# Attachment 1: Errata to EA and DRs

The following corrections apply to the environmental assessment (EA), which was issued on October 2, 2006, and its accompanying discipline reports (DRs) for the I-405, Renton Nickel Improvement Project, I-5 to SR 169. The DRs were completed in 2005 prior to the completion and issuance of the EA.

**Exhibit 4-2. Project Overview Section 1**

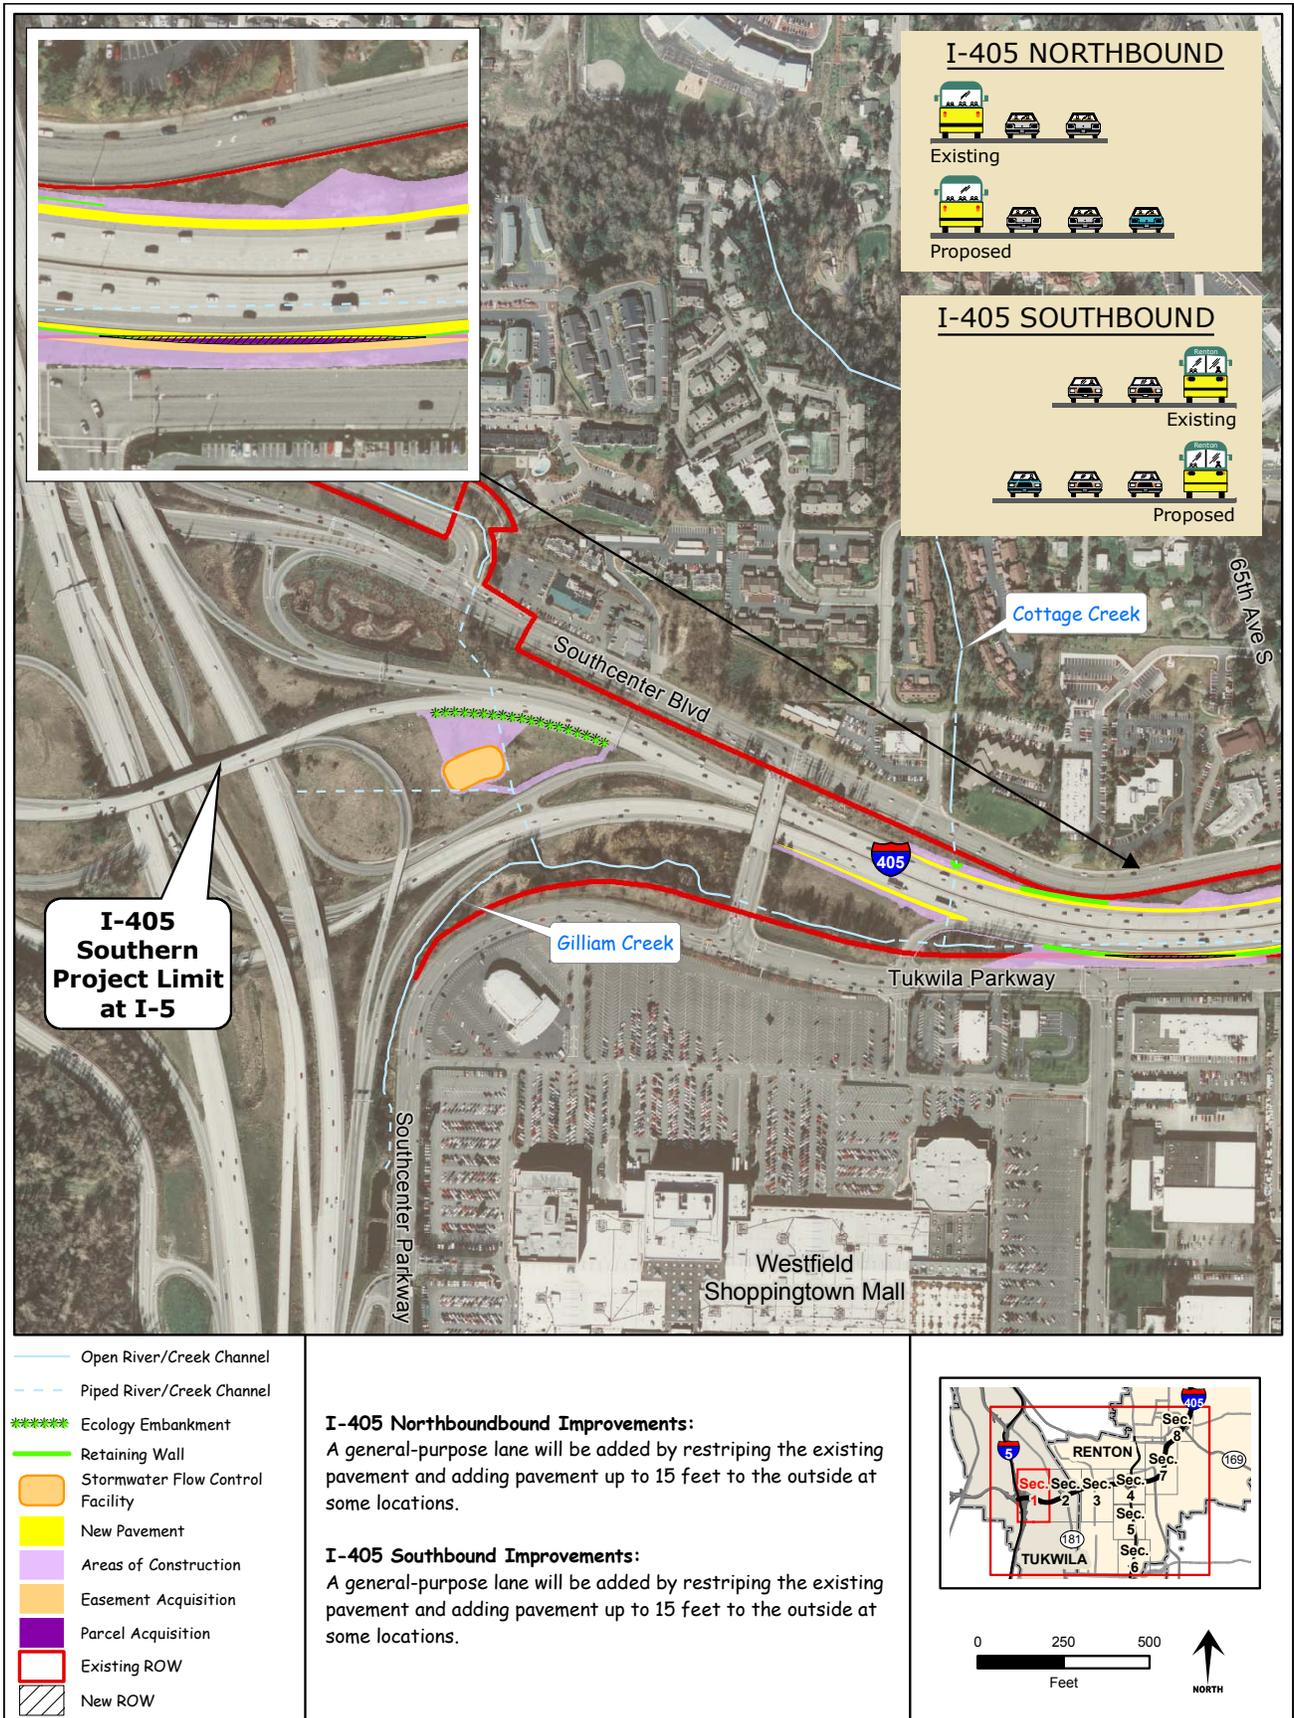
These exhibits have been revised to correctly display the Waters of the U.S. and not include stormwater drainages. See revised exhibits on pages A1-2 through A1-9.

**Exhibit 4-8. Project Overview Section 7**

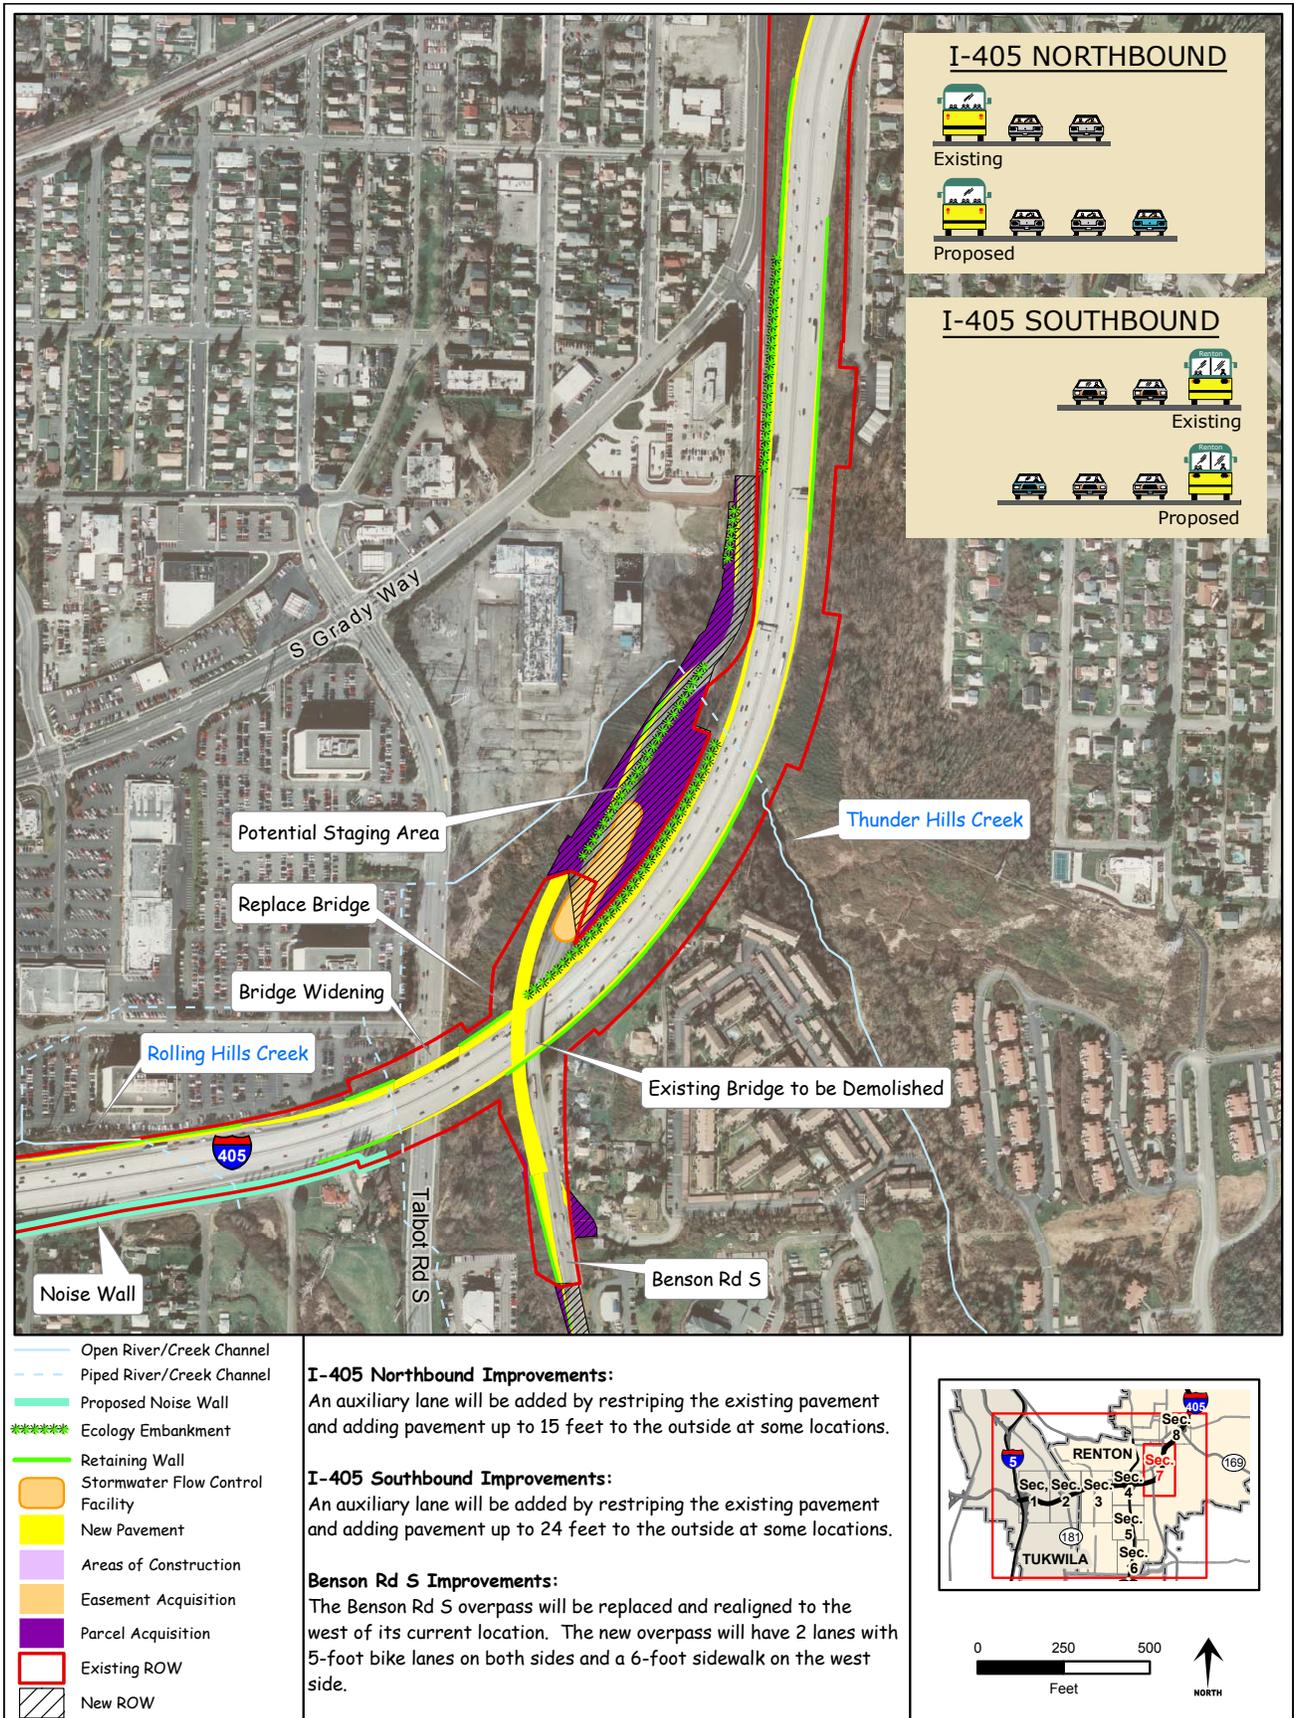
- Replace the rail on the I-405 bridges over ~~SR 181 and the Union Pacific and Burlington Northern Santa Fe~~ railroads.
- Remove the bridges over Springbrook Creek Side Channel and Oakesdale Avenue and replace them with a single northbound and a single southbound structure that will span Springbrook Creek's main channel and side channel and Oakesdale Avenue. Replace the I-405 bridges over Springbrook Creek Side Channel and Oakesdale Avenue with a single northbound and a single southbound structure, and remove the Springbrook Creek box culvert. See Exhibit 4-4.
- Widen the I-405 bridge over Talbot Road Bridge on both the northbound and the southbound sides. See Exhibit 4-8.
